RE: Enterprise Recycling and Disposal Facility
Cell 6 Construction Completion Report – RAI No. 1 Response
Angelo's Aggregate Materials, Ltd.
FDEP Permit Nos. 177982-008-SC/T3 and 177982-007-SO/T3
WACS No.: 87895
Pasco County, Florida

Limerock Details and Elevation Observations

Figure 1

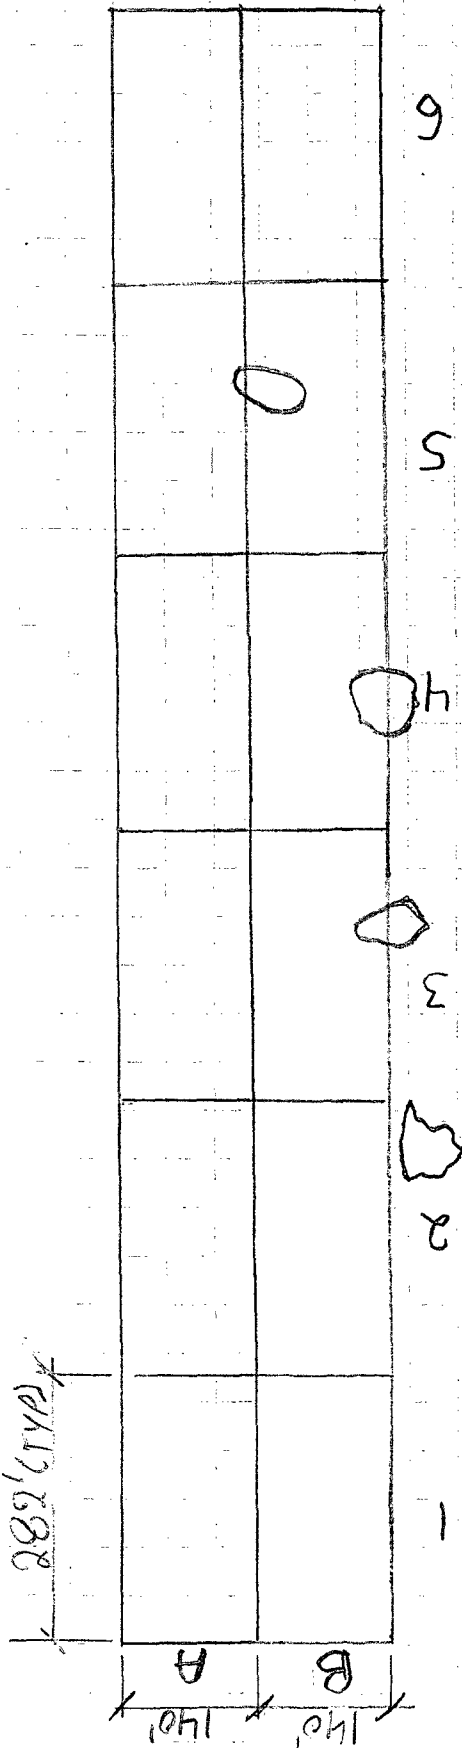
1. *As indicated in of October 28, 2011 cover letter to the report, Specific Condition #B.2.a.(2) of Permit 177982-008-SC/T3 states that "The Record Documents shall include, but shall not be limited to, as-built elevations of the disposal areas (surveys), details and elevations of limerock encountered, and other details as appropriate." While the "Weekly Photographs" submitted with the certification report appear to show limerock encountered during construction, neither the certification report nor the record drawings surveys submitted appear to include "details and elevations of limerock encountered" during the construction of Cell 6. Please verify and revise the certification report to provide this information.*

Details and elevations of limerock observed during the construction of Cell 6 are based on the daily field observations performed by John Arnold, P.E. Limerock was observed at locations in testing grids B-5, B-4, B-3, and west of B-2, as shown in Figure 1. The lateral and vertical extents of the limerock are based on relative observations and field measurements made from construction grade stakes installed by the land surveyor, Simmons and Beall, Inc. On a weekly basis 10 to 20 grade control stakes were installed in the work area to facilitate construction and observation activities. Elevations refer to NGVD '29 datum.

Limerock in B-5 was encountered at latitude $28^{\circ} 19' 49''\text{N}$, longitude $82^{\circ} 08' 04''\text{W}$ at an elevation of approximately 100' NGVD. As excavation of the overburden progressed westward, the extent of the limerock was determined to be approximately 65' long by 75' wide. The limerock was firm to hard with a clay mantel. No soft zones or voids within the limerock were observed. The limerock pinnacle/outcrop maximum elevation was 115' NGVD (+/-). The west edge of the limerock pinnacle/outcrop extended to an elevation of 79' NGVD (+/-). All limerock exposed at this location was over-excavated to a depth of 3' as required to construct the 3' thick clay barrier layer.

Limerock in B-4 was encountered at latitude $28^{\circ} 19' 52''\text{N}$, longitude $82^{\circ} 08' 04.8''\text{W}$ at an elevation of approximately 108' NGVD. As excavation of the overburden progressed westward, the extent of the limerock was determined to be approximately 75' long by 50' wide. The western most extent of the limerock will be determined at a later date with the mining of the area west of Cell 6. The limerock was firm to hard with a clay mantel. No soft zones or voids within the limerock were observed. The exposed limerock pinnacle/outcrop maximum elevation was 110' NGVD (+/-) and minimum elevation of 79' NGVD (+/-). All limerock exposed at this location was over-excavated to a depth of 3' as required to construct the 3' thick clay barrier layer.

Limerock in B-3 was encountered at latitude $28^{\circ} 19' 54''\text{N}$, longitude $82^{\circ} 08' 05''\text{W}$ at an elevation of approximately 112' NGVD. As excavation of the overburden progressed westward, the extent of the limerock was determined to be approximately 50' long by 80' wide. The western most extent of the limerock will be determined at a later date with the mining of the area west of Cell 6. The limerock was firm to hard with a clay mantel. No soft zones or voids within the limerock were observed. The limerock pinnacle/outcrop maximum elevation was 115' NGVD (+/-) and minimum elevation of 79' NGVD (+/-). All limerock exposed at this location was over-excavated to a depth of 3' as required to construct the 3' thick clay barrier layer.

Limerock in the area west of B-2 was encountered at latitude $28^{\circ} 19' 56''\text{N}$, longitude $82^{\circ} 08' 06.8''\text{W}$ at an elevation of approximately 90' NGVD. As excavation of the overburden progressed westward, the extent of the limerock was determined to be approximately 100' long by 40' wide. The western most extent of the limerock will be determined at a later date with the mining of the area west of Cell 6. The limerock was firm to hard with a clay mantel. No soft zones or voids within the limerock were observed. The limerock pinnacle/outcrop maximum elevation was 112' NGVD (+/-) and minimum elevation of 88' NGVD (+/-). Limerock exposed at this location was over-excavated to a depth of 3' as required to construct the 3' thick clay barrier layer.
